Access Compliance Report

Public Rights-of-Way

Intersection ID: 53925	Main Street: RORY_GLEN_LN	Cross Street: PINYON_PINE_LN	Location: NE
ADA ID: 446C8557EF9D	Ramp Type: PerpDiag	Initial Pass/Fail: Fail	Overall Compliance: No
Severity Score: 46.25			
Codes/Mitigation Info/Possible Solution		Field Measurements/Component Compliance

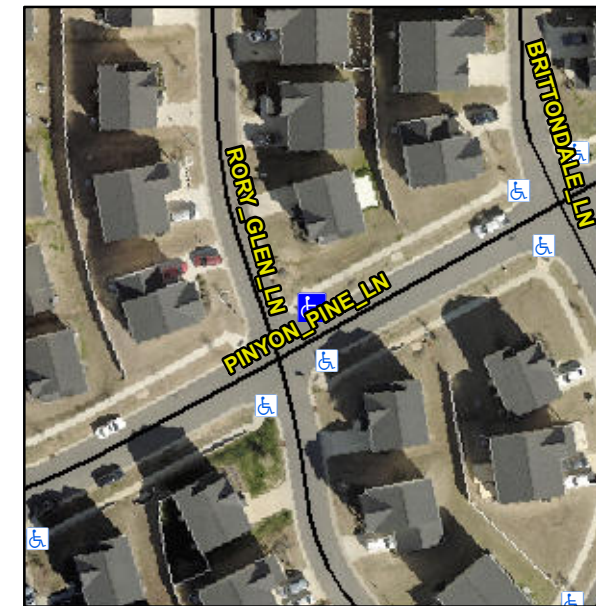
Not Found, R304.5.1, R304.2.2, R304.5.3

Compliance	Description	Data	Compliance	Description	Data
N/A	Ramp Length (in)	104.5	No	Ramp Slope (%)	9.3
No	Ramp Width (in)	42.0	No	Ramp XSlope (%)	7.4
N/A	Flare Type LT	N/A	N/A	Flare Type RT	N/A
N/A	Flare Slope LT (%)	N/A	N/A	Flare Slope RT (%)	N/A
N/A	Flare Traversable LT?	N/A	N/A	Flare Traversable RT?	N/A
N/A	Landing Length (in)	N/A	N/A	DWS Provided?	N/A
N/A	Landing Width (in)	N/A	N/A	DWS Contrast?	N/A
N/A	Landing Slope (%)	N/A	N/A	DWS Length (in)	N/A
N/A	Landing X Slope (%)	N/A	N/A	DWS Full Width?	N/A
N/A	Landing Curb? (Y/N)	N/A	N/A	DWS Offset (in)	N/A
N/A	Shared Landing?	N/A			
N/A	Gutter Ponding?	N/A	N/A	Gutter Slope (%)	N/A
N/A	Gutter Lip Ht (in)	N/A	N/A	Gutter X Slope (%)	N/A
N/A	Painted X Walk1?	No	N/A	Painted X Walk2?	No
	X Walk 1 Direction	To SW		X Walk 2 Direction	To S
N/A	X Walk 1 Width (in)	N/A	N/A	X Walk 2 Width (in)	N/A
	X Walk 1 Slope (%)	5.6		X Walk 2 Slope (%)	2.2
	X Walk 1 X Slope (%)	4.8		X Walk 2 X Slope (%)	6.2

N/A	Ramp inside XWalk1?	N/A	N/A	Ramp inside XWalk2?	N/A
	Road Slope (%)	7.7	N/A	Clear Space?	N/A
	Road X Slope (%)	0.6	N/A	Clear Space to XWalk (in)	N/A
N/A	Any Obstructions?	N/A	N/A	Storm Grate/Utility Hazard?	N/A
	Obstruction Type			Storm Grate/Utility Type	
		N/A			N/A
			Yes	Surface Condition? (G/P)	Good

Remove & Replace Curb Ramp With Two New Directional Ramps or Equivalent.
